BRITISH GLIDING ASSOCIATION

BGA TECHNICAL COMMITTEE

TECHNICAL NEWSHEET TNS 9/10/93

STANDARD CIRRUS ELEVATOR CONNECTION

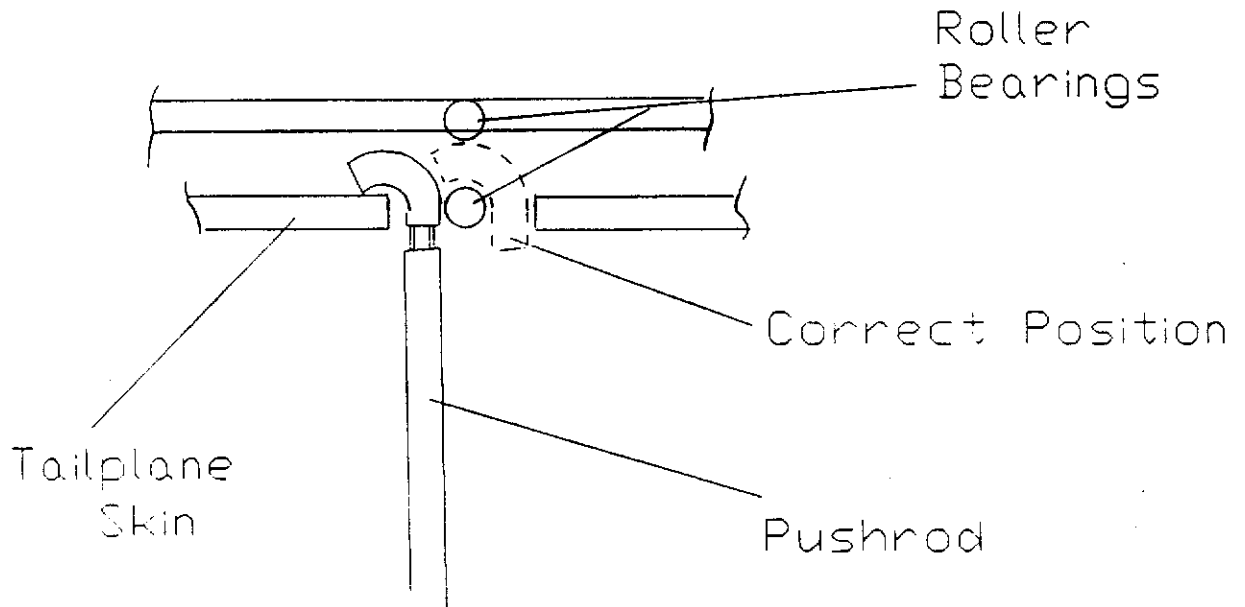
The pilot of a Standard Cirrus found that he was unable to reduce speed below 45 Kt following a winch launch, after landing it was found that the Elevator Pushrod to tailplane connection had been incorrectly fitted as shown in the diagram below.

This fault could not be detected by a positive control check and was difficult to observe visually, it also proved impossible to reproduce this fault on refitting the tailplane.

JANUS C. UNDERCARRIAGE LEVER.

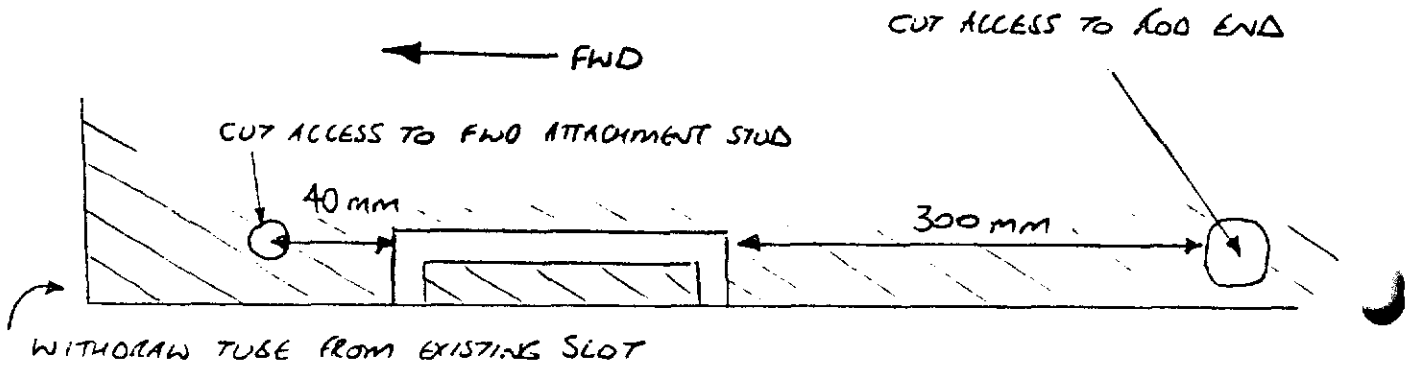
WHILE ATTEMPTING TO LOWER THE U/D ON A 10 YEAR OLD JANUS C, THE OPERATING LEVER SEPARATED FROM THE DRIVE ROD. THE FAILURE OCCURRED AT THE WELD BETWEEN THE LEVER AND THE DRIVE ROD TUBE WALL.

THE FOLLOWING DIAGRAM MAY BE OF USE TO OTHER JANUS OR NIMBUS II OPERATORS WHO MAY NEED TO REMOVE THE U/D RETRACTION DRIVE ROD.

LBA-AD 93-157

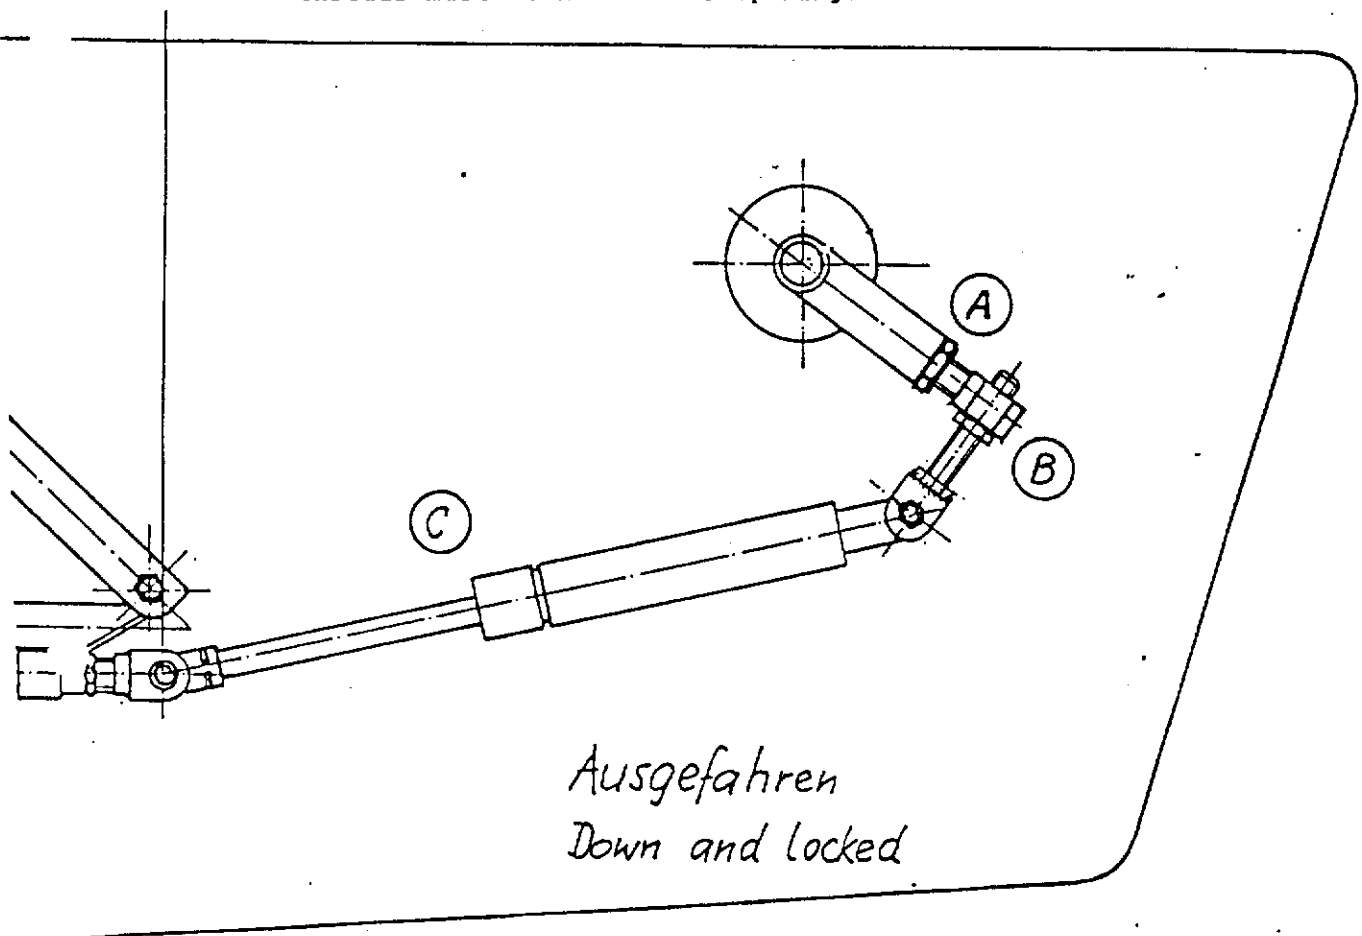
REASON : Landing gear locking failed due to improper locking of nuts.

Drawing of landing gear drive at the left side of the landing gear box, adjustments at A and B, accessible after removal of the baggage compartment cover. When fitting a new gas strut C the following must be checked: During locking the gas strut must be compressed by about 5 to 8 mm (0.2 to 0.3 in) to ensure total strut force acting as preset load for locking.

MATERIAL and INSTRUCTIONS : Check locking of nuts in the landing gear drive:
A) Thread M10, Width over flats 19 mm, torque 45 Nm (33 lb*ft)
B) Thread M8, width over flats 17 mm, torque 25 Nm (18 lb*ft)
Additional safety by applying thread securing fluid (for example: Loctite)

Additional safety by applying thread securing fluid (for example: Loctite). For later adjustments, these secured threads must be heated for opening.

Drawing of root rib and air brake drive, indicating regions for adjustment of
play:

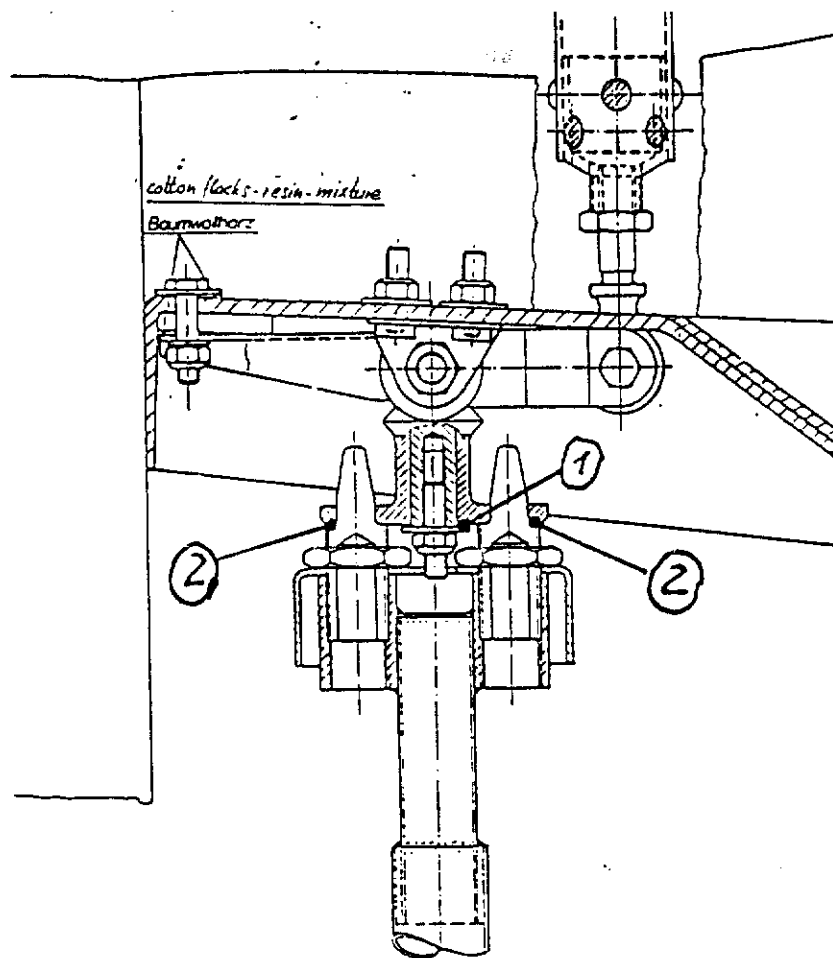
REASON : With excessive play in bevel gear drive at root rib or at fuselage drive between root ribs, the retaining bolt of the gear drive plate may fail.

MATERIAL and INSTRUCTIONS : 1) Check play in bevel gear drive at root ribs:
The bevel gear drive plate must be axially free from play, but should be unbraced. Compensation of play by shims 16*12 mm (When this play is excessive, the plate may skip over one or more teeth, resulting in air brake being either not completely retractable or extendable). See also drawing on page 2.

2) After rigging the plane - check spanwise play of fuselage air brake drive between bevel gears with air brakes not locked. Also, this value must be free from play, but unbraced.
Compensation of play by shims 14*10 mm.
(When this play is excessive, the root rib is being deformed during locking, resulting in possible failure of the bevel gear plate retaining bolt and also air brake being either not completely retractable or extendable).

3) Modification of the air brake bevel gear unit to version "a" (Drawing 1DF-4a), identifiable by locking nut M8, width over flats 13 mm at the gear drive plate, instead of locking nut M6, width over flats 10 mm.
Disassembly of bevel gear units as follows:
a. Mark bevel gear meshed using permanent marker, eventually after degreasing with white spirit.
b. Mark gear unit with serial number of plane and R or L for left or right unit.
c. Dismount units from wings and send them to the manufacturer for modification.

ROLLADEN-SCHNEIDER Flugzeugbau GmbH LBA-Nr. EB - 4	Arbeitsanleitung BA-4 Höhenleitwerksaufhängung zu TM 3043 / 4035	LS3-a LS3-17 LS4, -a	Blatt 1/1 Ausgabe Juli 93
--	--	----------------------------	------------------------------

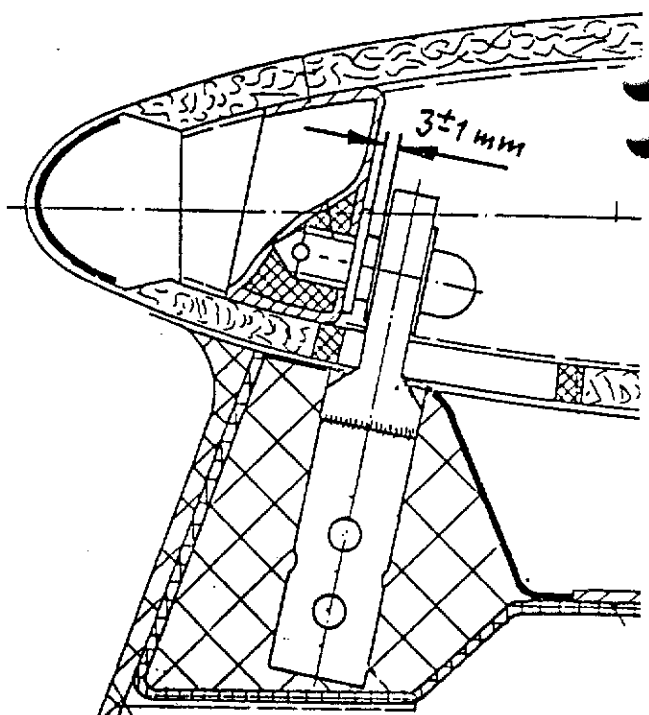
REASON : In one case the forward elevator mounting bracket on the vertical tail fin became loose.

MATERIAL and INSTRUCTIONS : Check the forward elevator mounting bracket for the following:
: Fixture of the bracket by applying a torque 15 Nm (max. 6 kg (13 lbs) at lever arm 0.25 m (10 in)) at the bracket housing, without applying load to the bonded-in ball.
Cracks in paint around bracket may indicate a loose mounting.

If the bracket is loose, repair with a new bracket 4R4-7c according to Instruction BA-4. When the bonding of the ball is loose, re-bond with elevator fitted.

- 1) Losen Beschlag aus der Bohrung in der Seitenflossen-Abschlußrippe ziehen.
Extract loose bracket from vertical tail fin.
- 2) Rippenbohrung innen mittels Schleifer auf volle Länge aufrauhen, aber nicht vergrößern.
Sand mounting orifice in rib internally along whole length using a grinder, but do not enlarge diameter.

- 4) Rohr des neuen Beschlags 4R4-7c mit Baumwoll-Harz-Gemisch füllen, ebenso Bohrung in der Rippe. Harz: SCHEUFLER L285 + Härter L286, 100:38
RÜTAPOX L20 + Härter H91, 100:26
*Fill tube of bracket and mounting orifice with mixture of cotton flocks with epoxy resin. Resin: SCHEUFLER L285 + hardener L286, 100:38
RÜTAPOX L20 + hardener H91, 100:26*

Datum	Name	Rolladen-Schneider Flugzeugbau GmbH	Maßstab: 1:1	
Gez.	9.3.93	U.	Benennung: Höhenleitwerkssicherung	Zeichn.-Nr. 4BR-164	
Bes.	1.7.93	Gesch.			
Gepr.	2. JULI 1993	Stempel			
Oberflächensch.: ✓			Kompl vor:	BZ-Nr.	
Rißprüfung: ✓				BZ-Nr.	
Pos.	Stck.	Benennung	DIN/LN	Werkstoff	Zeichn.-Nr.

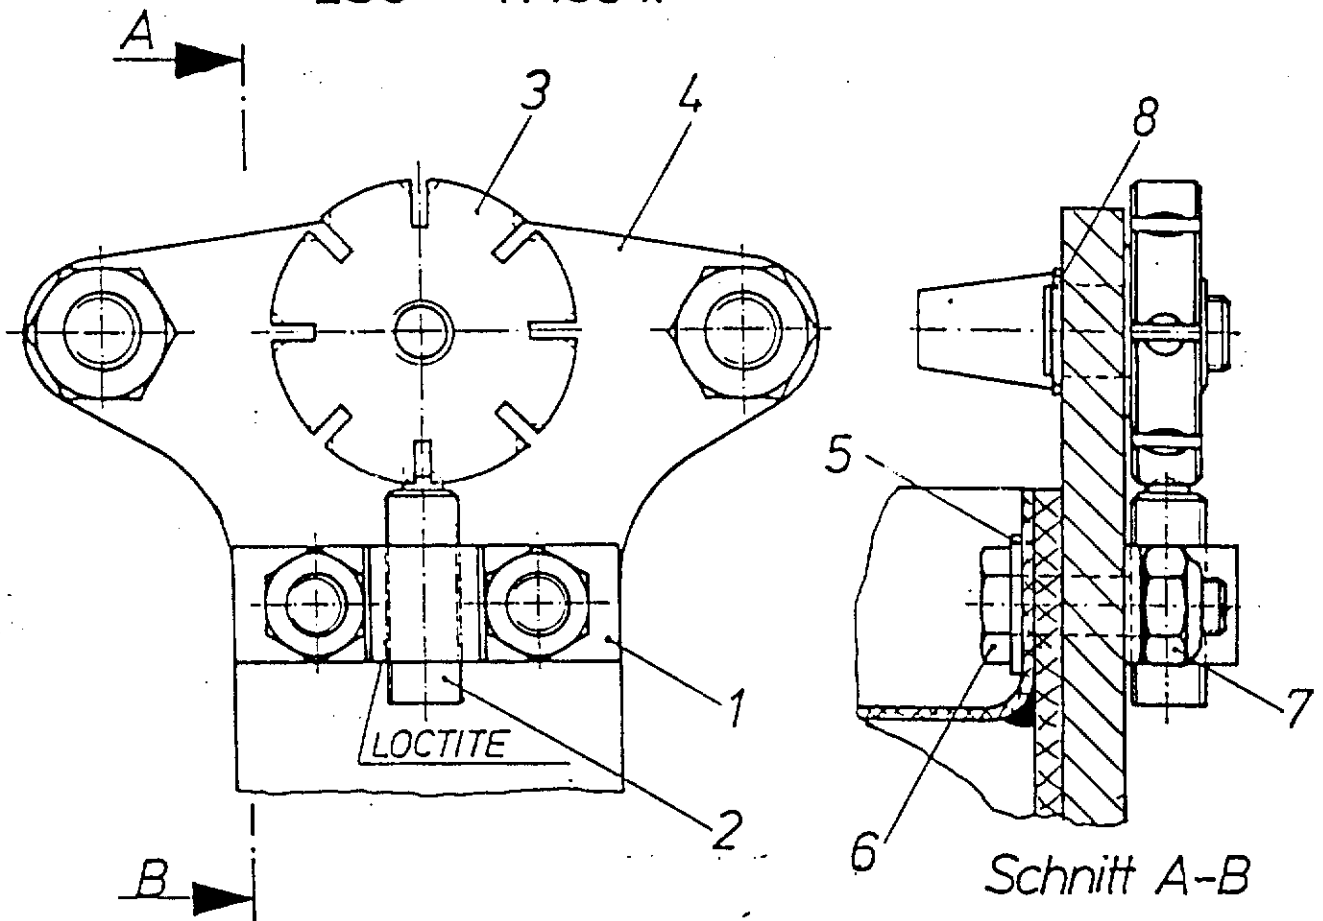
REASON : The horizontal tail locking spring may be exchanged against a spring loaded ratchet (Similar to the ones used in later LS sailplane models).

MATERIAL and INSTRUCTIONS : Installation according to drawing 4BR-164. With the horizontal tail unit fitted, the ratchet housing (part No. 4R4-19) should not touch the securing nut (part No. 4R4-8a), the ball should protrude into the recesses of the securing nut. Housing must be secured in base plate by use of Loctite or similar.

Hotellier Control System Connectors

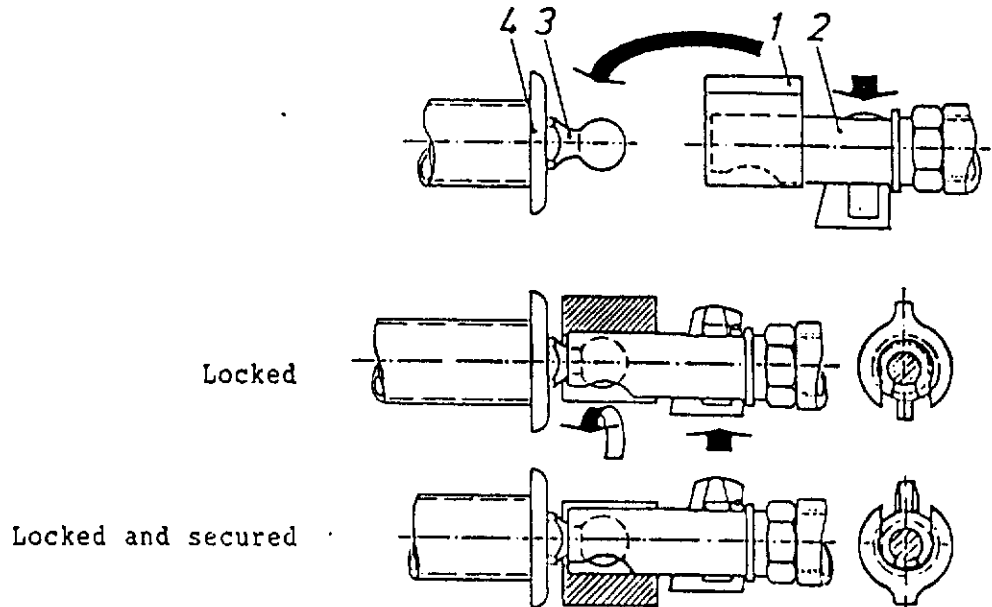
REASON : These connectors may open during use when they are not secured.

Warning: With connectors unsecured, the locking plate may open under load temporarily ! The locking plate should never be greased !

MATERIAL and INSTRUCTIONS : Securing may be performed using sleeve 4R10-170 according to specification SR10-170 dated 10.05.93. This sleeve replaces a securing pin. (For LS3-a and LS3-17 only the lefthand connector may be secured with this sleeve). Installation according to drawing 4BF-101. Insert page "Flight Manual LBA-AD 93-001" into Flight Manual, 2 pages "TB-AD-Accomplishment List for Periodical Inspections" into Maintenance Manual (Instructions for Continued Airworthiness) and update list of valid pages.

Prior to assembly, everybody should be familiar with the functioning of the Hotellier control system connectors (a.k.a. ball snap joints or clip and ball coupling). With the locking plate fully pressed, each connector (2) must be engaged fully on the ball (3). During securing, the locking plate moves slightly backwards. Using the securing sleeve (1), installation is possible only with the slot facing down, respectively the rib facing up. After proper connection and turning the sleeve by 180 degrees, the joint is secured, see also sketch below.

SINGSBY CAPSTAN Rudder Post - Checked.

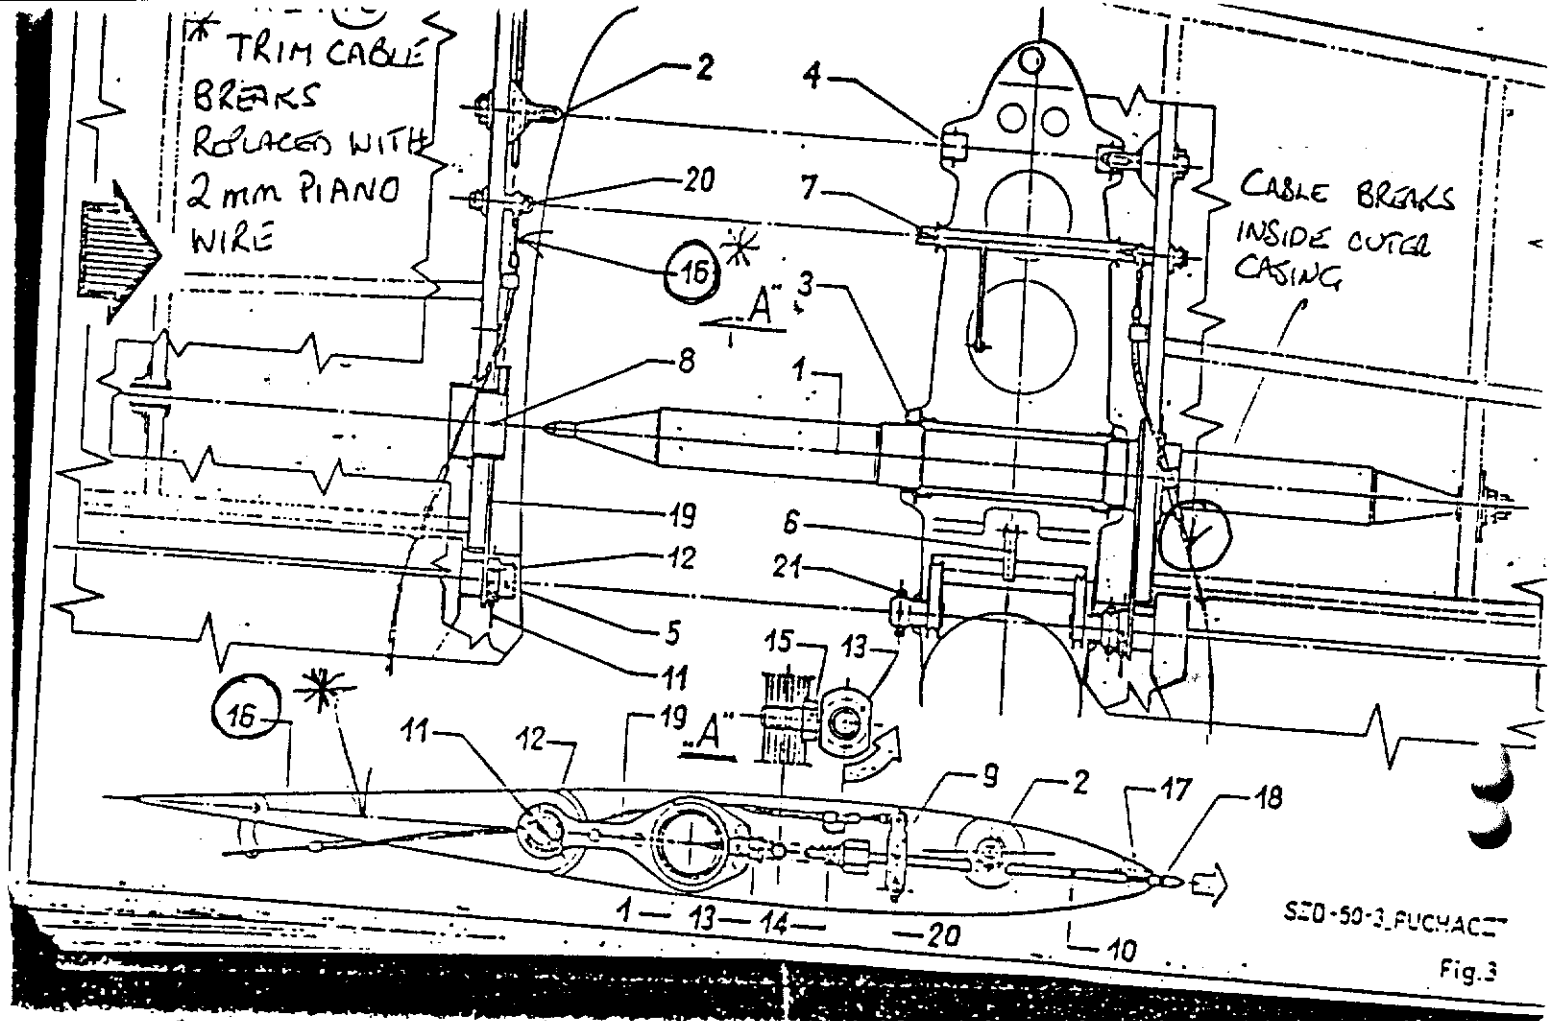
- 1.22. SLINGSBY CAPSTAN - Rudder Post cracked at welds. (Sketch from RNGC Culdrose).
- 1.23. Puchacz - Elevator Trim Tab Drive Failures. 2mm solid wire cable fails inside the outer casing. Repaired with locally manufacturer cable. (Sketch herewith from Southdown G.C.).

End view of harness slide

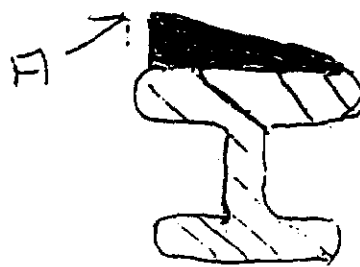
When the harness strap slides (that part which moves up and down during adjustment) were manufactured there was a rough face from the casting of the aluminium. With time this rough face has worked smooth and the straps slide over it freely.

To prevent this I had the tops of the slide built up with MIG welding by about 3mm and then milled back at 45 degrees to give a raised face on the strap release side.

Dark portion is built up by MIG welding and then milled to 45 degrees

The edge A is somewhat serrated from the un-milled welding, and helps the strap grip even more. Cost was \$7.50 per slide for first four experimental slides, doubtless it would be cheaper by the dozen.

E3. SPARK PLUG FAILURE

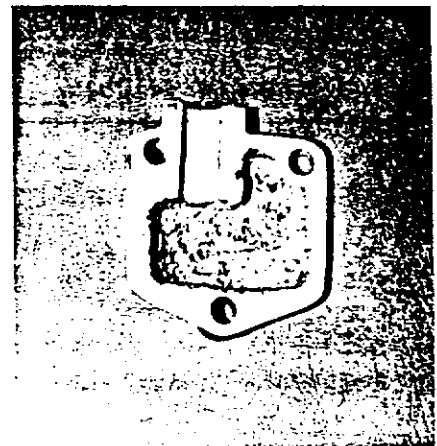
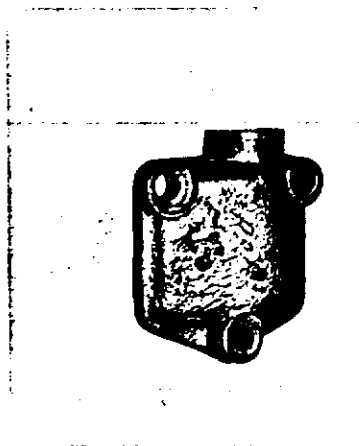
Engineering examination showed that one spark plug, the starboard front lower, had a broken electrode insulator.

The reporter advised that similar failure took place a year ago but, 140 hours after that event one, of the new plugs was found with a cracked insulator. He points out that the defect is only apparent after a period of full power, not on normal ground checks.
